PREVOST

**SAFETY
RECALL**

Sr11-10

DATE : MARCH 2011	SECTION : 03-FUEL
SUBJECT : REPLACEMENT OF THE FUEL TANK SUPPORT

APPLICATION OF SELF-ADHESIVE NEOPRENE FOAM (dark area)

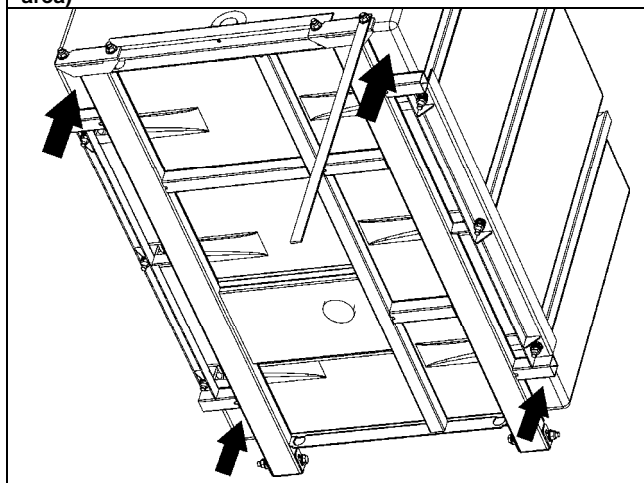
3. Apply self-adhesive neoprene foam (p/n 506758) on the new platform as shown.
4. Lift the vehicle.

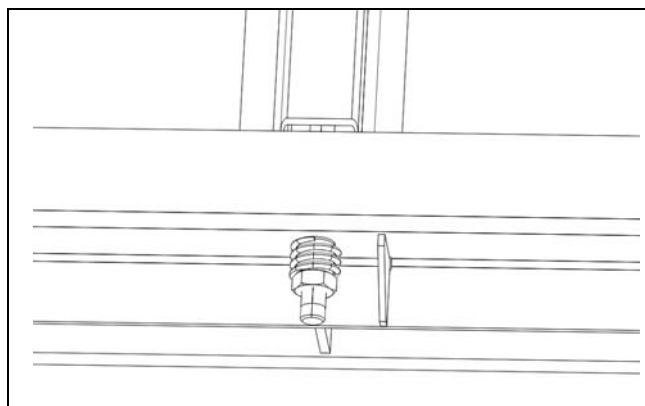
7. Unscrew the bolts (6) holding the fuel tank support to the vehicle chassis.
8. Replace the existing fuel tank support with the new one. Identify the defective support so it will not be reuse.
9. Install the new support with **new** hardware (bolts, washers and nuts).
 - Tighten bolts to 50 lb-ft (5 bolts)
 - Tighten bolts to 25 lb-ft (with static wick)
